**To:** Planning Committee  
**From:** Wayne Craig  
Director, Development

**Date:** February 12, 2021  
**File:** RZ 20-891369

**Re:** Application by Speera Ventures Incorporated for Rezoning at  
10620 Williams Road from the "Single Detached (RS1/E)" Zone to the "Compact  
Single Detached (RC2)" Zone

**SITE PLAN**  
**PROPOSED 2 LOT SUBDIVISION**

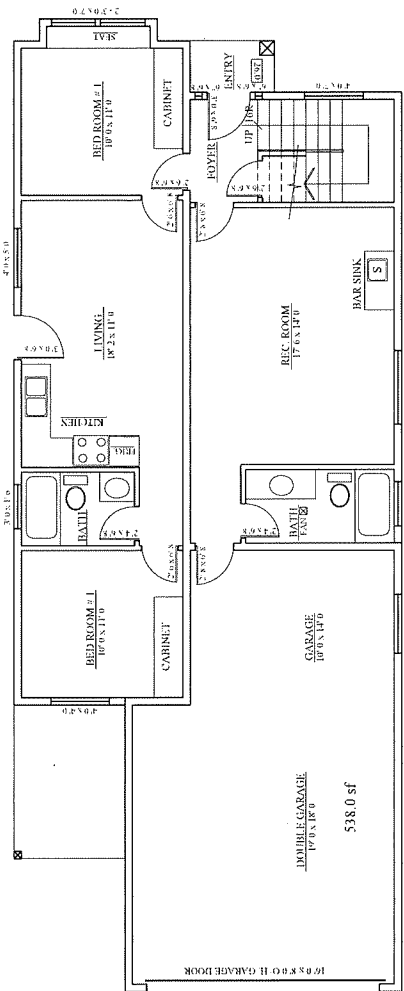
The proposed development is generally in compliance with the “Compact Single Detached (RC2)” zone in Richmond Zoning Bylaw 8500. However, in order to maintain a 4.87 m tree protection zone around tree tag# 001 in the front yard, the applicant is requesting two variances. The first variance is to reduce the minimum rear yard setback from 6.0 m to 3.18 m to accommodate the proposed building on Lot 2. The second variance is to allow the minimum 20 m<sup>2</sup> of private outdoor space to be located in the front yard on Lot 2.

By reducing the rear yard setback requirement of 6.0 m to 3.18 m, an attached garage can be provided, and the front yard tree can be protected. With the building footprint on Lot 2 shifted towards the rear and tree protection and secondary suite parking requirements reducing available exterior space, the private outdoor space would need to be included in the front yard instead of the rear yard.

Staff support the requested variance as it will enable retention of the tree. The variances are required to be considered through a Development Variance Permit (DVP). The processing of a DVP to the satisfaction of the Director of Development is required prior to the adoption of the rezoning bylaw. Subdivision approval is required prior to DVP issuance as the variances are requested for Lot 2 only.

**Tree Management Plan V1**

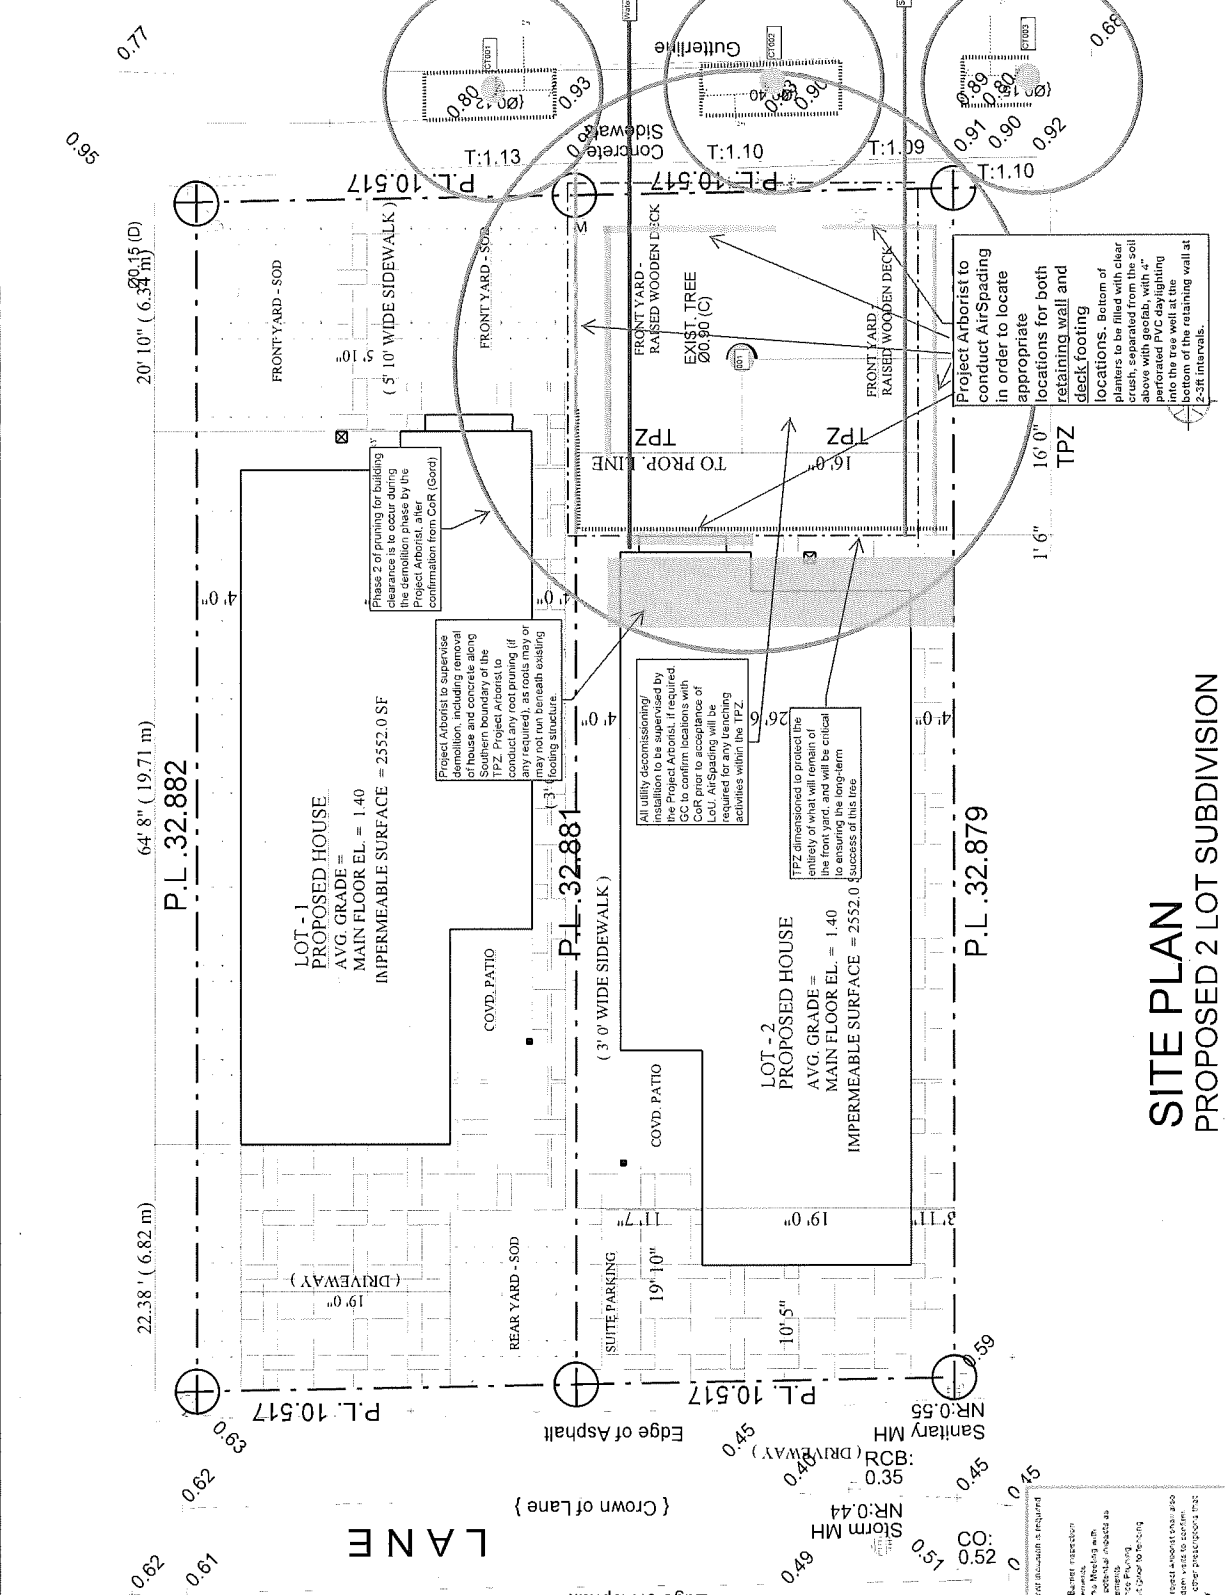
Four trees (tag# 001, CT001, CT002, CT003) are to be retained and protected. The applicant has submitted a tree protection plan showing the trees to be retained and the measures taken to protect them during development stage (Attachment 6). To ensure that the trees identified for retention are protected at development stage, the applicant is required to complete the following items:

- Careful consideration of the existing grade within the Tree Protection Zone surrounding tree tag# 001 is required. Existing site grade is lower than the sidewalk therefore in order to save tree tag# 001, the grade within the TPZ cannot be manipulated. To ensure existing grade is maintained in the TPZ, a raised wooden deck is proposed. Placement of footings for the deck will be reviewed prior to Building Permit issuance, with the help of a Certified Arborist, to ensure roots of the tree are not impacted and ground drainage is addressed.

- A variance to the rear yard setback and to the location of the required private outdoor space would help achieve tree retention in the front yard of Lot 2 and improve use, accessibility and functionality around tree tag# 001.

- Prior to final adoption of the rezoning bylaw, submission to the City of a Tree Survival Security in the amount of \$40,000.00 to ensure 4 trees (tag# 001, CT001, CT002, CT003) are retained and protected.
- Prior to demolition of the existing dwelling on the subject site, installation of tree protection fencing around all trees to be retained. Tree protection fencing must be installed to City standard in accordance with the City’s Tree Protection Information Bulletin Tree-03 prior to any works being conducted on-site, and remain in place until construction and landscaping on-site is completed.
